**NEW YORK STATE THRUWAY AUTHORITY  
DEPARTMENT OF ENGINEERING**

**AMENDMENT NO. 1  
TO**

**CONTRACT TANY 24-34B  
D215005  
REPLACEMENT OF MEADOW HILL ROAD  
BRIDGE OVER I-87, NYS THRUWAY  
AT MILEPOST 60.95  
IN THE NEW YORK DIVISION  
OF THE NEW YORK STATE THRUWAY  
IN ORANGE COUNTY**

DRAWING NUMBER:  
**TC-7**

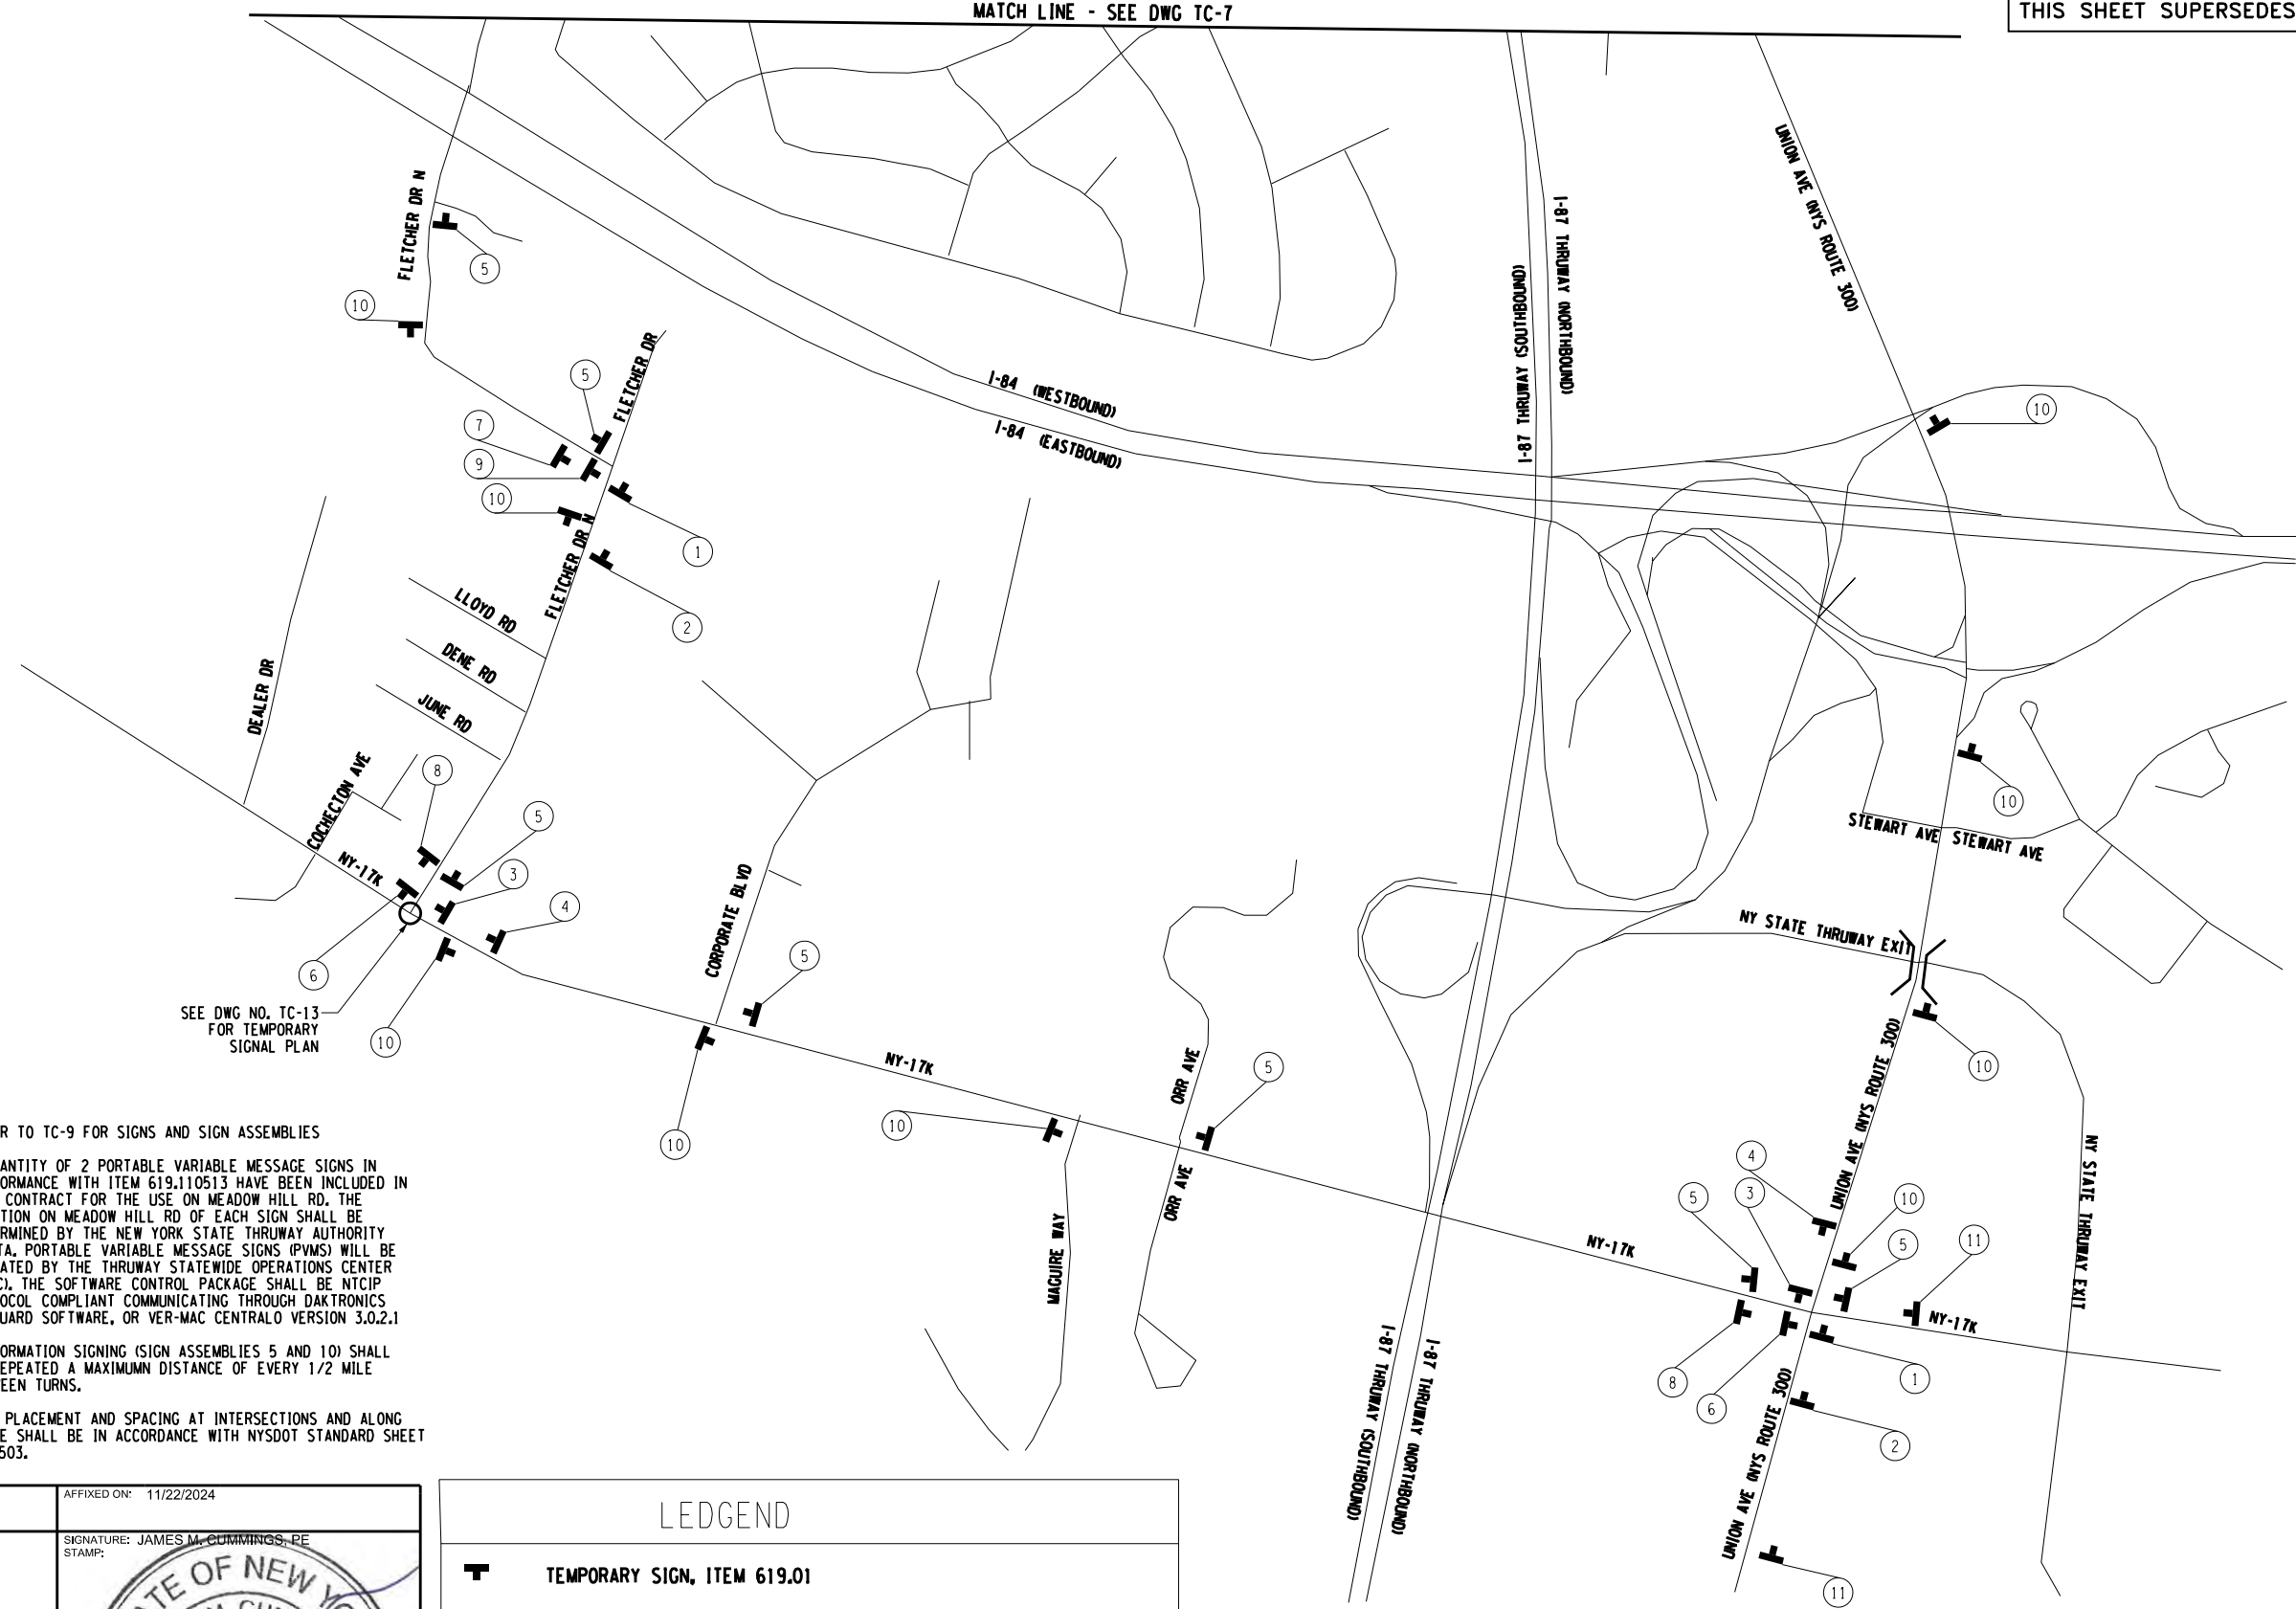
5. Any reference to Item 210.3313 in the contract plans shall be substituted with Item 210.481201 instead.
6. **DELETE** Drawing Number TC-7, Sheet 15 of 98 and **SUBSTITUTE** with the attached Drawing Number TC-7, **Sheet 15-A1** of 98. Note 4 has been added to the drawing.

TITLE OF PROJECT MEADOW HILL ROAD BRIDGE REPLACEMENT OVER NYS THRUWAY (MP 60.95)	CONTRACT NUMBER: TANY 24-34B
LOCATION OF PROJECT TOWN OF NEWBURGH ORANGE COUNTY BIN 5514380	DATE: 09/2024
TITLE OF DRAWING WZTC PLAN NYS RT 300/52 INTERSECTION	DRAWING NUMBER: TC-12

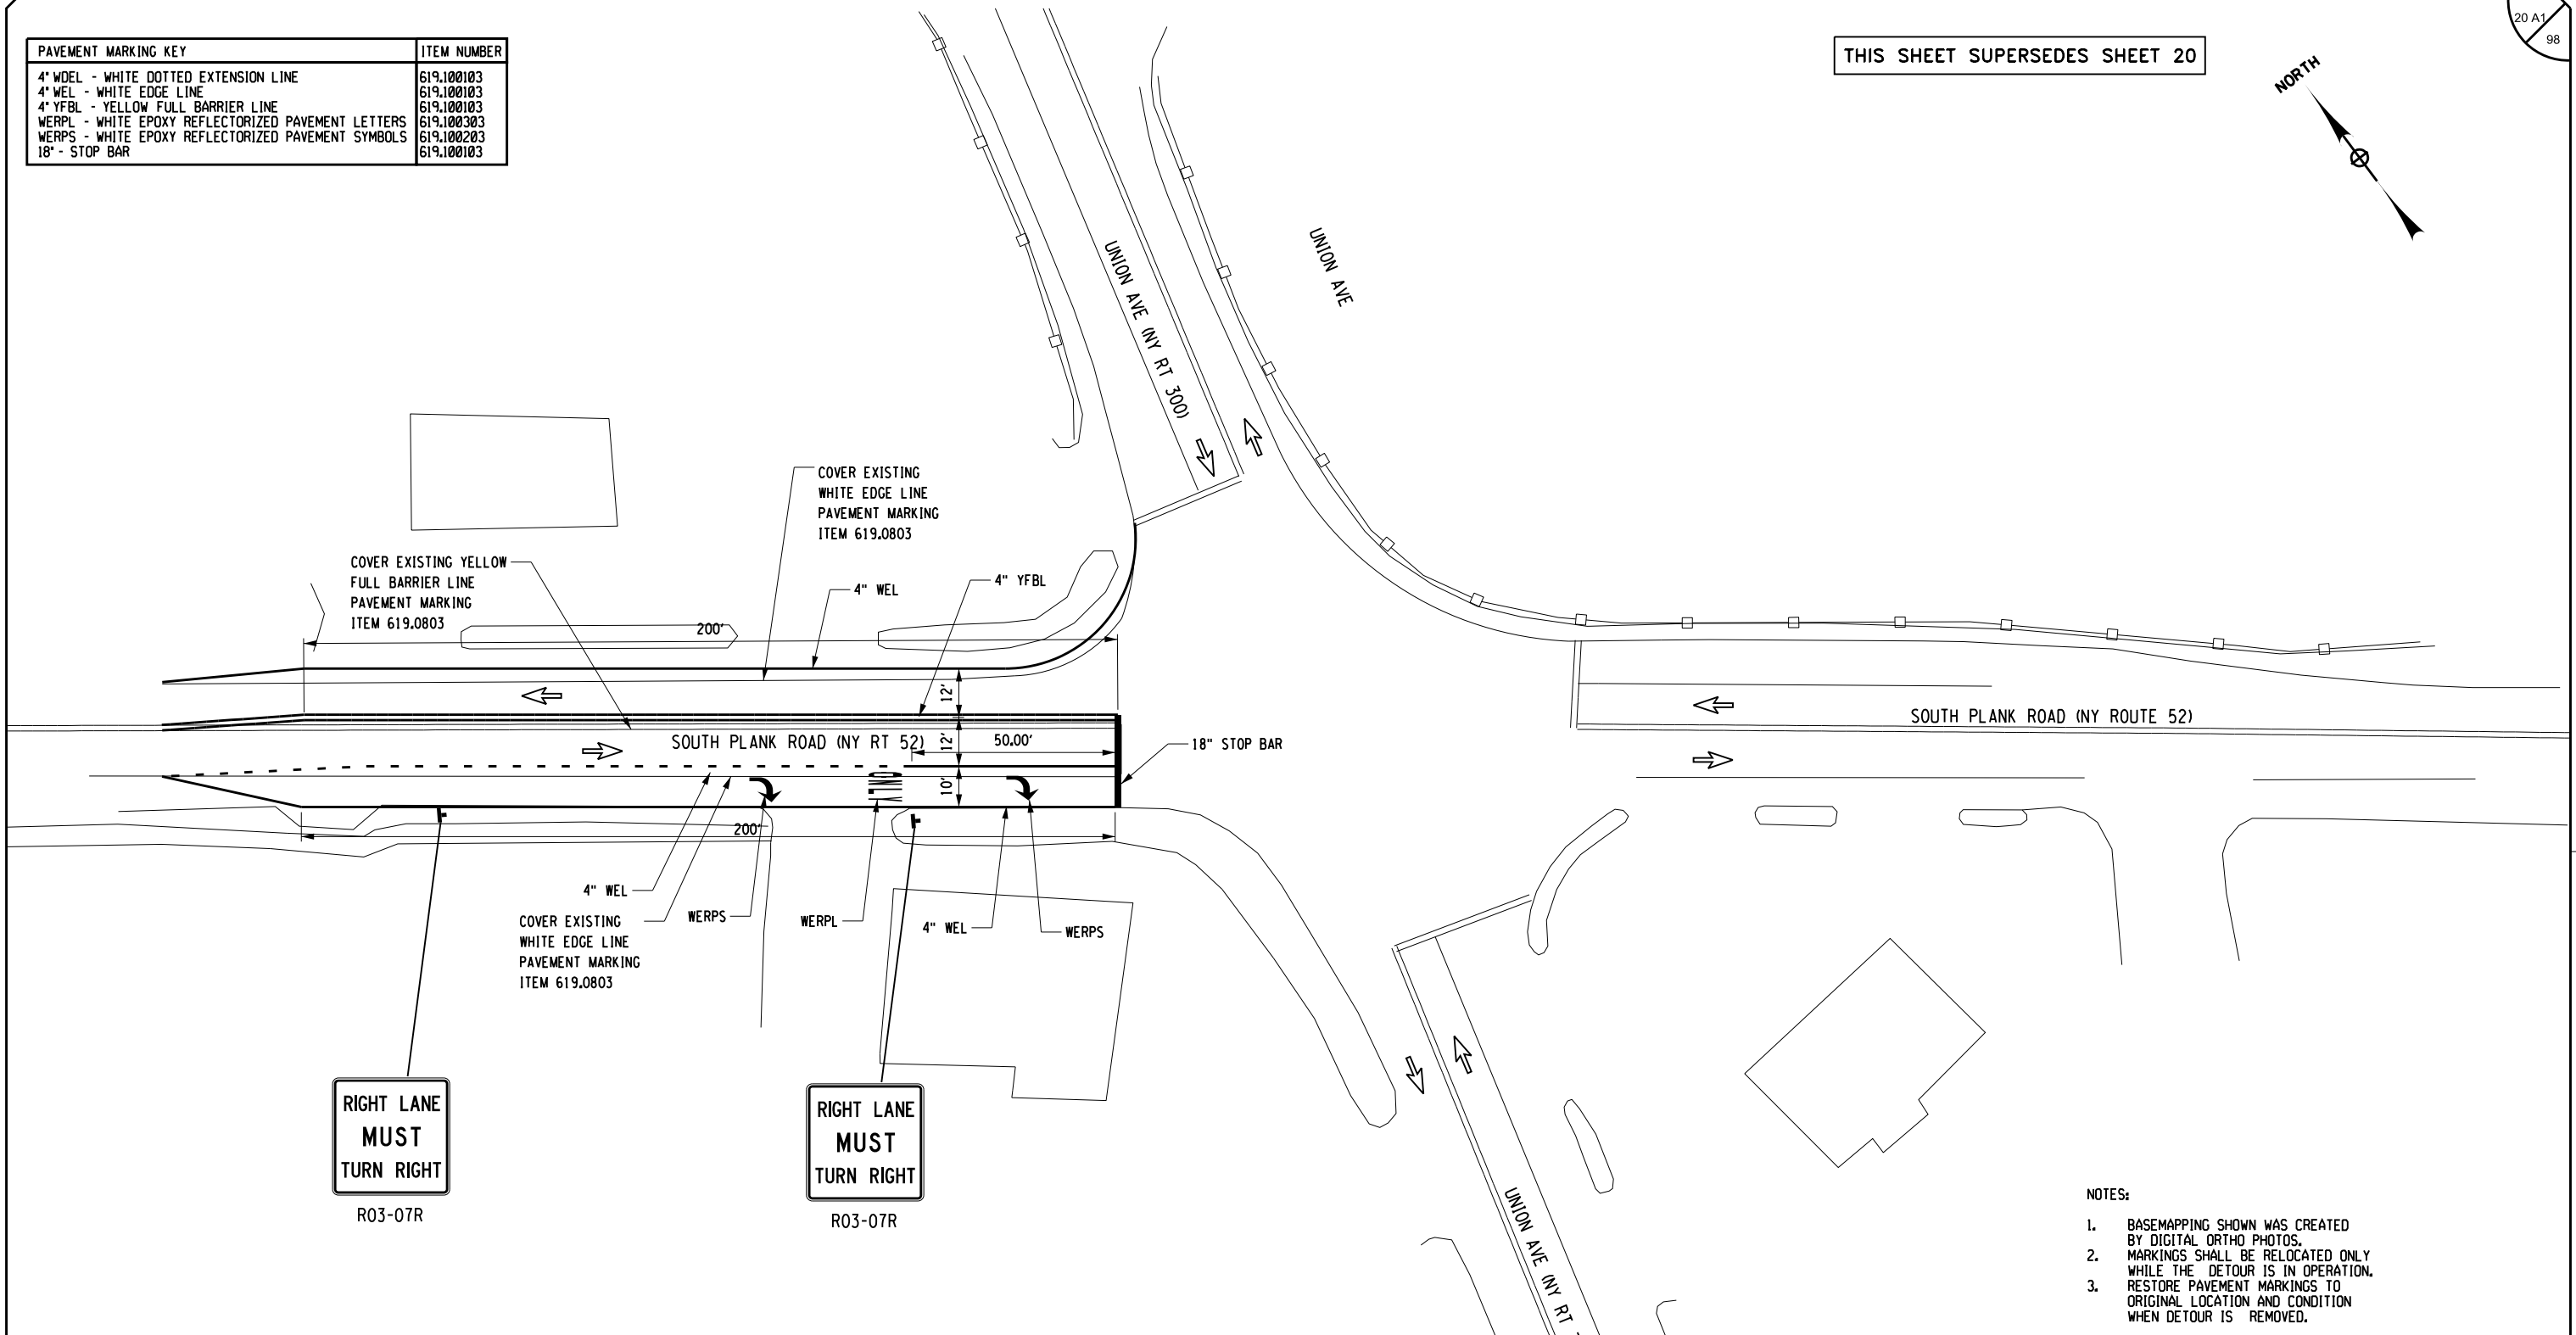
8. **DELETE** Drawing Number TC-12, Sheet 20 of 98 and **SUBSTITUTE** with the attached Drawing Number TC-12, **Sheet 20-A1** of 98. The length of the turning lane has been increased from 100' to 200' and additional signage has been placed at the intersection.

DRAWING NUMBER: TC-13

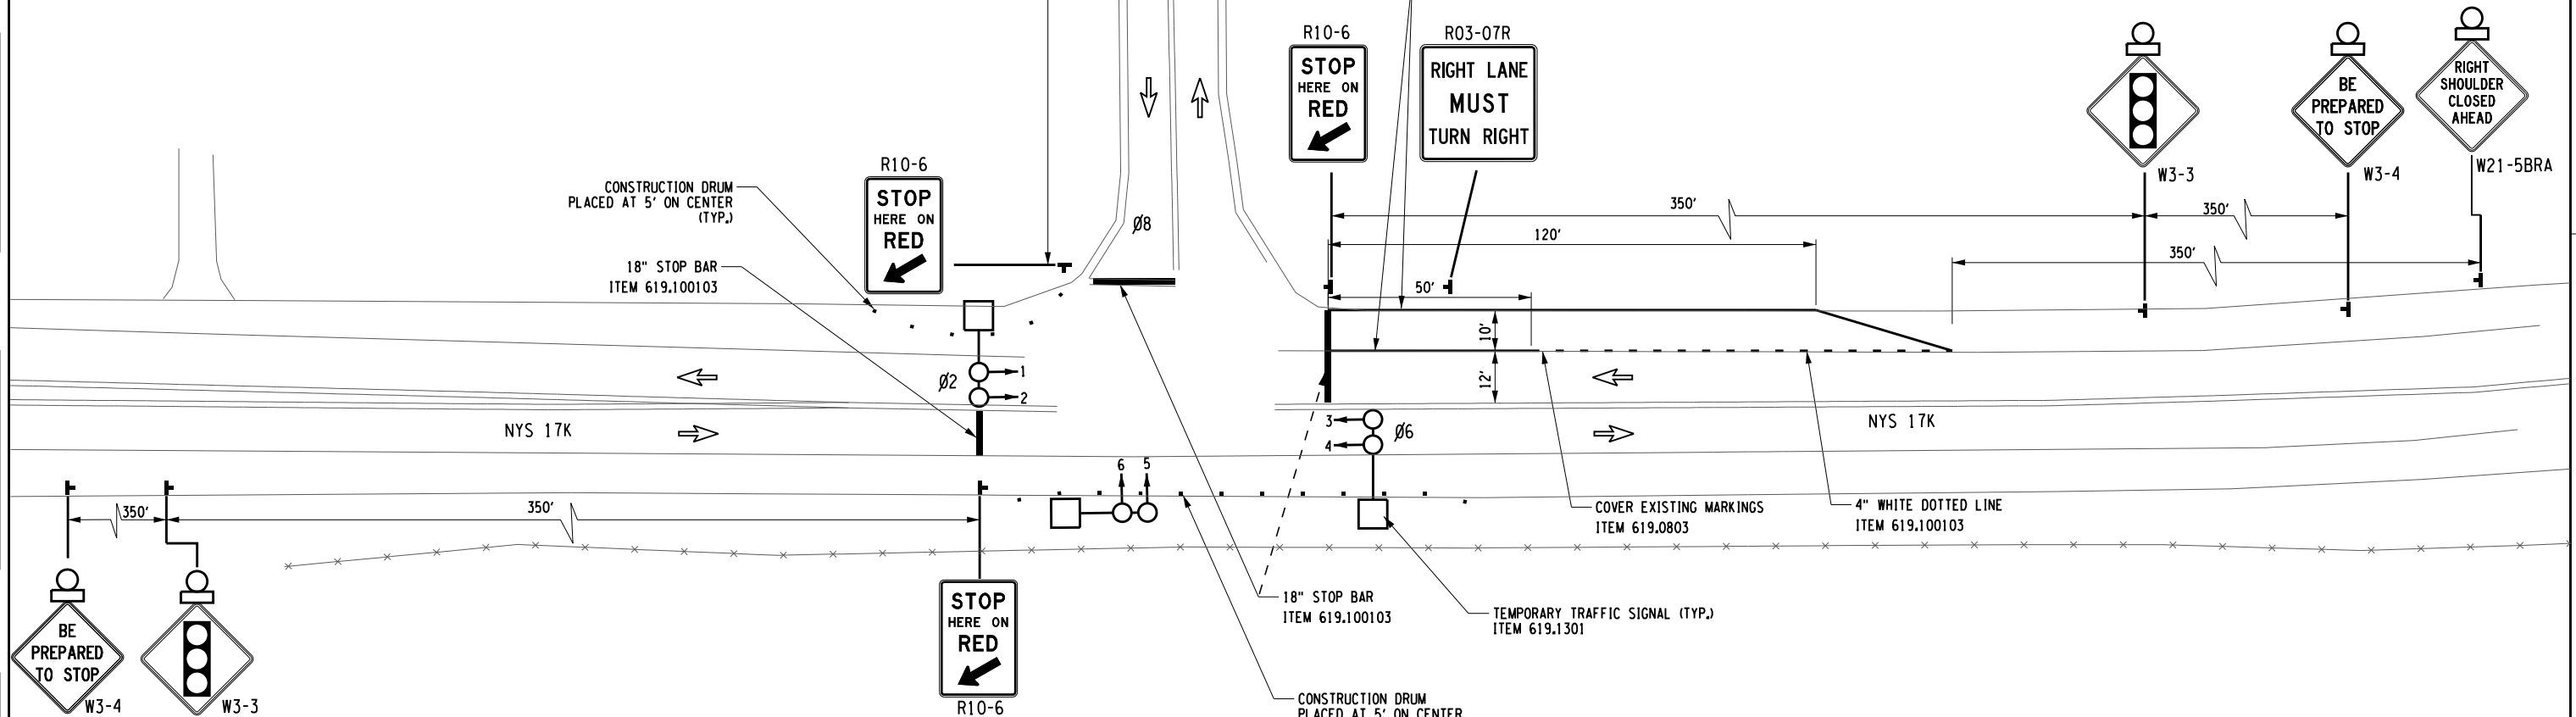
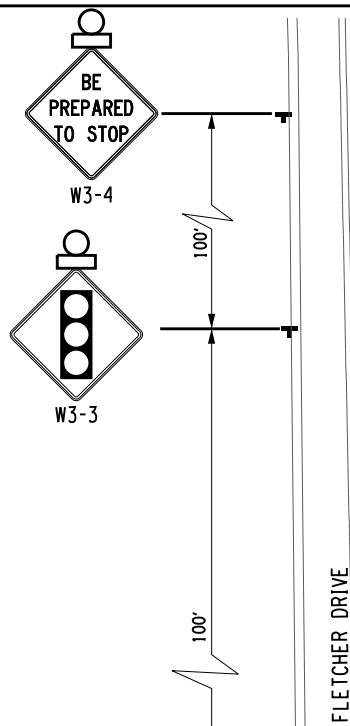
9. **DELETE** Drawing Number TC-13, Sheet 21 of 98 and **SUBSTITUTE** with the attached Drawing Number TC-13, **Sheet 21-A1** of 98. The lane configuration, sign layout, and signal timing at the intersection have all been modified.
